The Aldebot Residence

PLAN REVIEW COMMENTS

APPLICATION NUMB: ALT 071-22
DATE RECEIVED: April 8, 2022
LOCATION: 17 Greenfield Avenue

DESCRIPTION OF WORK : Proposed interior & exterior alteration.

1 PROP. PLOT PLAN

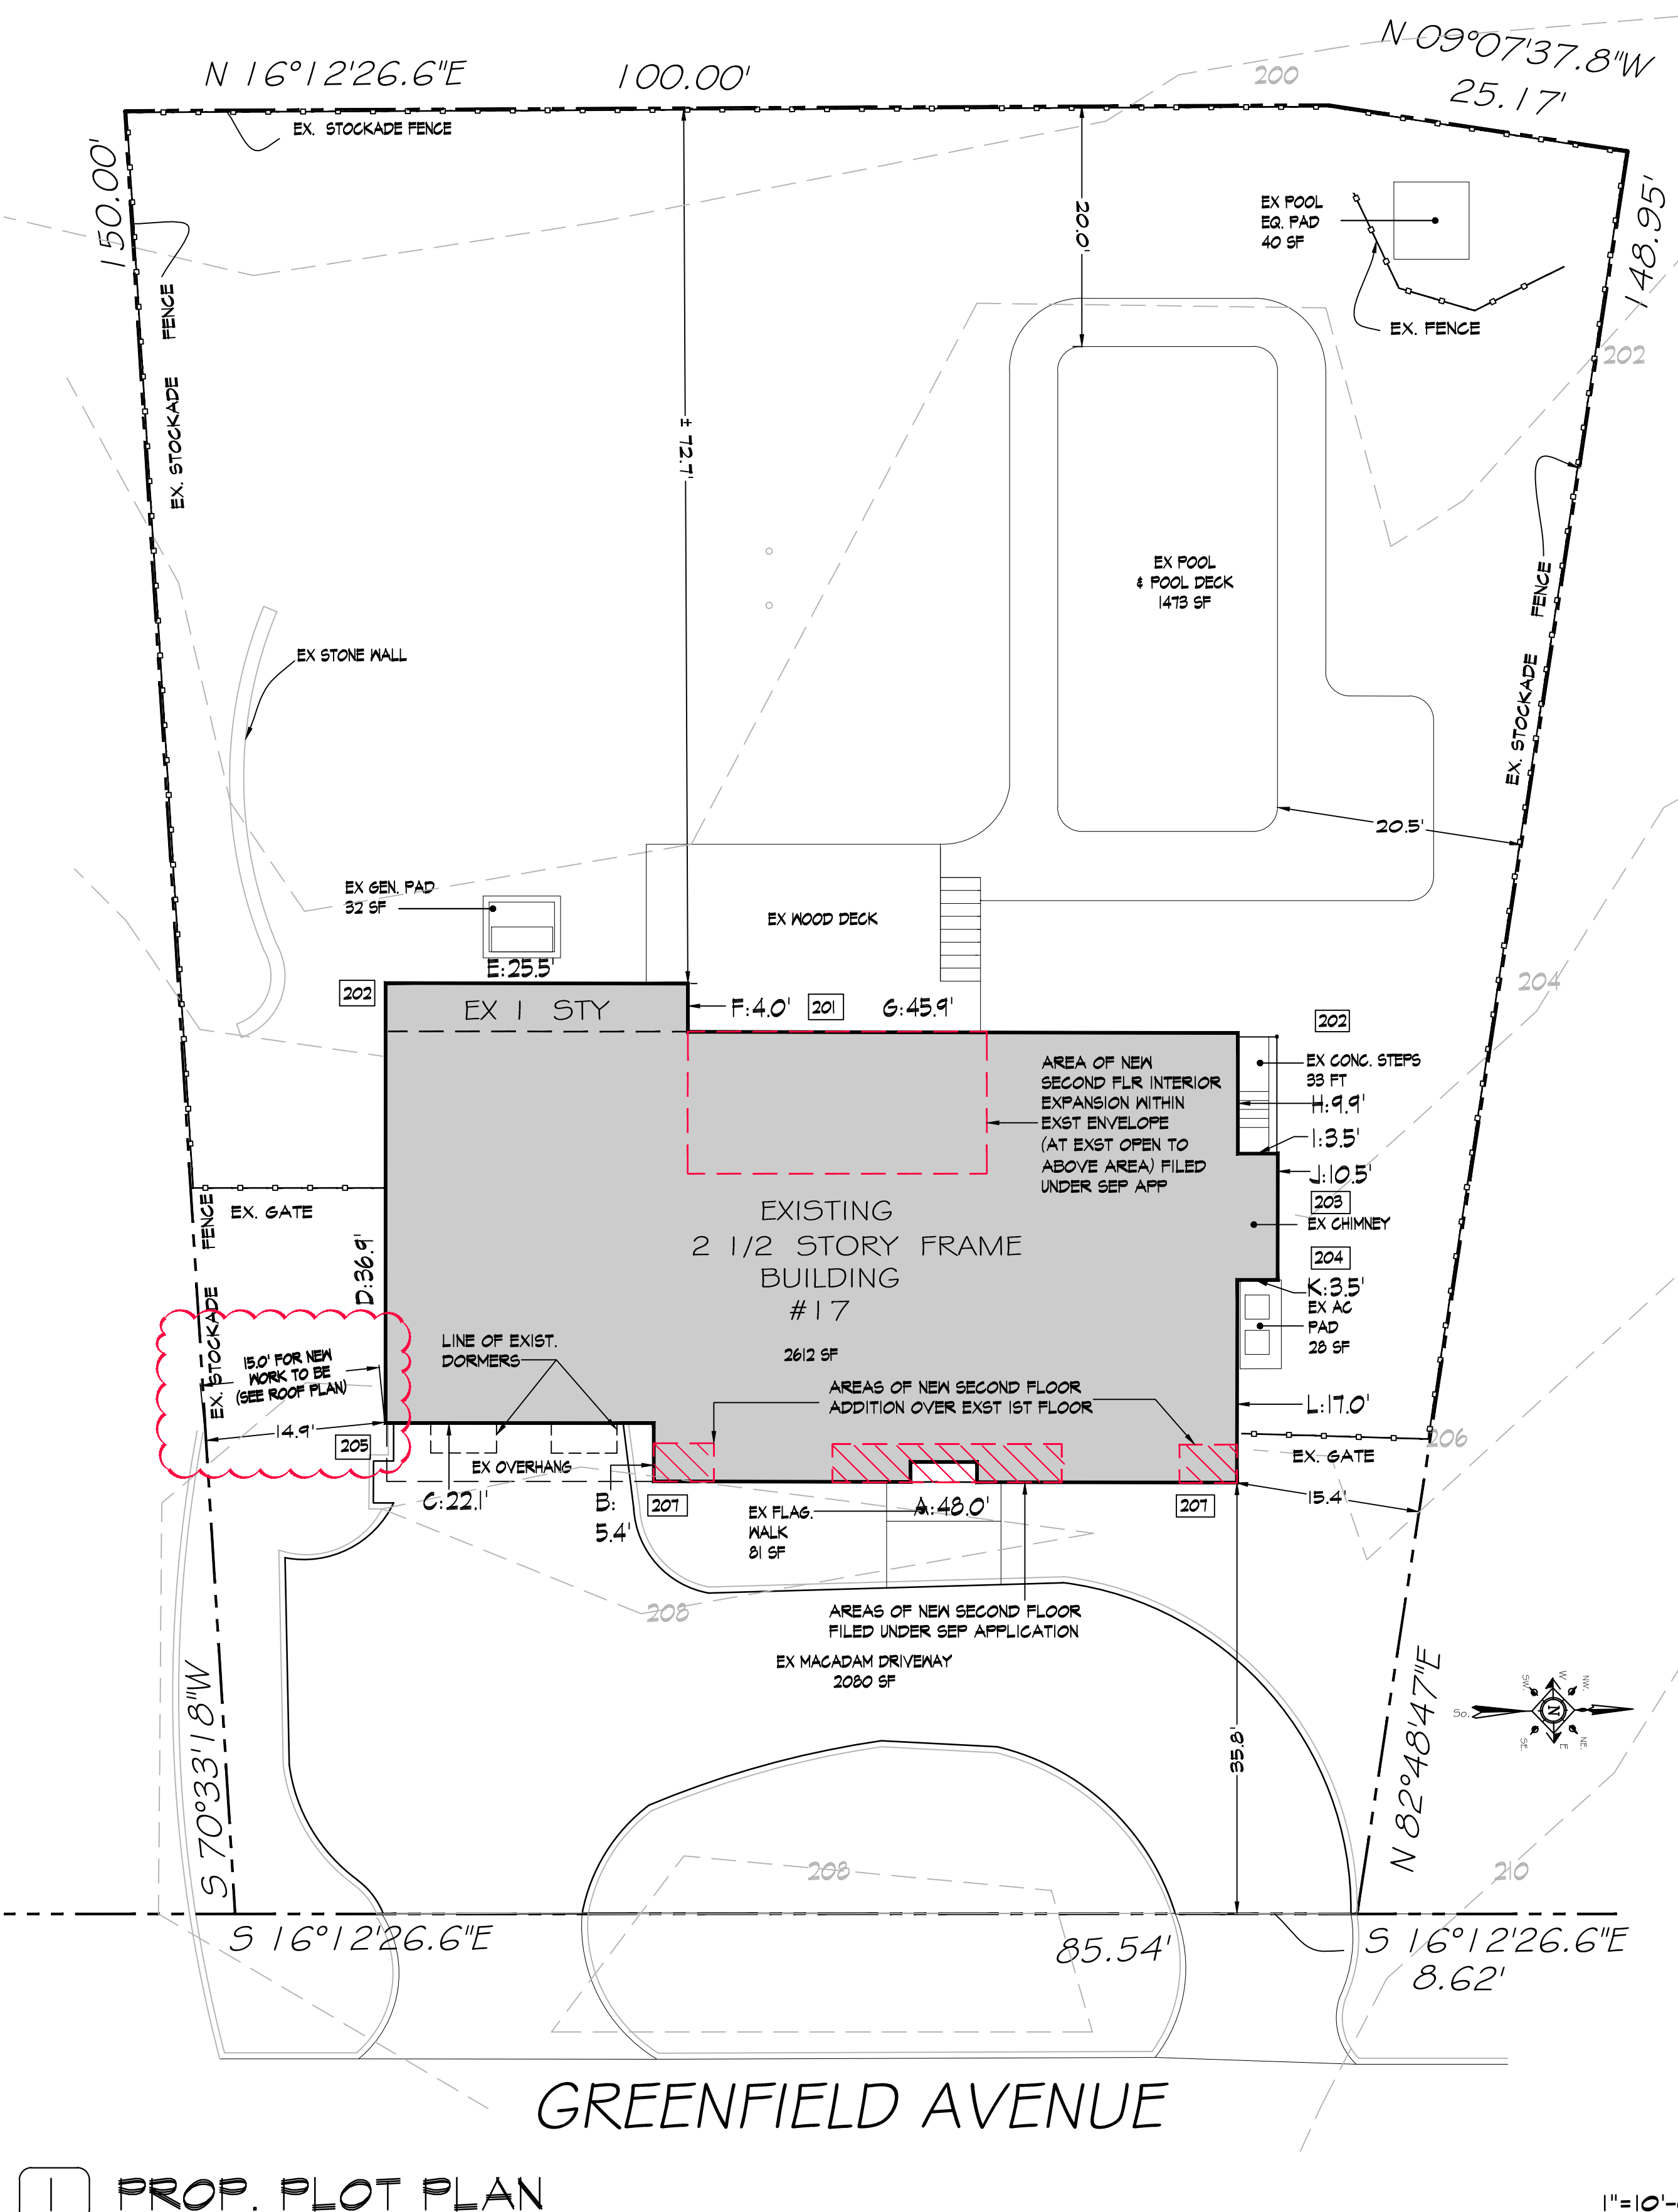
Comment #	Description	Sheet #
1	Scope of work provided describing full extent of work. Previously scheduled interior work has been filed under a separate permit on 05.25.22	T1
2	DRC/PB Application to be submitted separately for Improvements to Front Exterior Façade	--
3	Building Coverage Worksheet Calculations provided .	T2
4	Existing elevations updated to include dimensions	A2
5	Existing Second floor south east corner of wall is non-conforming at 14.9. No change is proposed to this wall. We proposed a gable end wall for the roof above and have updated the drawings to indicate that such wall shall be setback by 1" to comply with the 15ft setback reqmnt	
6	FAR Worksheet Enclosed & calcs included on sheet T1	T1
